Response to the U.S. Nuclear Regulatory
Commission Request for Additional Information on
the Draft Waste Incidental to Reprocessing Evaluation
for the West Valley Demonstration Project Vitrification Melter

June 16, 2011

West Valley Environmental Services

for the U.S. Department of Energy, West Valley, New York

Figure 2. Evacuated Canister Snorkel Concept
(from May, et al. 2003)

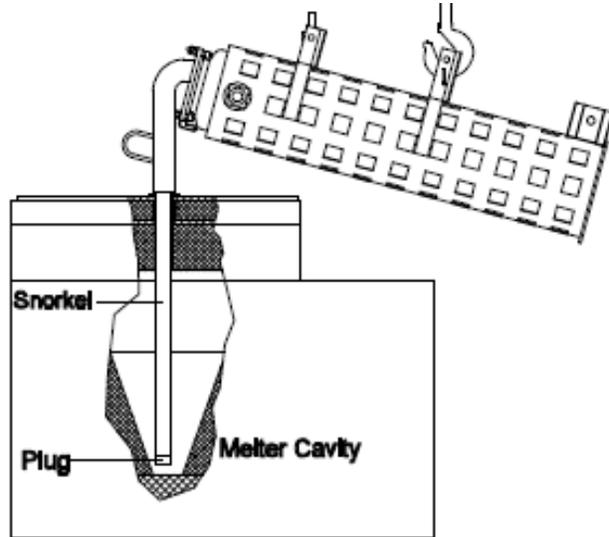
DOE response: As explained previously, the only way to remove material from the vitrification melter during operations was the airlift process, which was initiated when the glass pool level fell slightly below 26 inches, so material was not otherwise discharged via flushing. The evacuated canister system was designed to remove molten glass from the bottom part of the vitrification melter and this was done.

Figure 2 shows the approximate position of the end of the snorkel with respect to the bottom of the cavity. As noted previously, drawings show that the lower end was positioned so it would be drawing molten glass from a point approximately six inches from the bottom of the cavity for the first evacuated canister and two inches from the bottom for the second one.
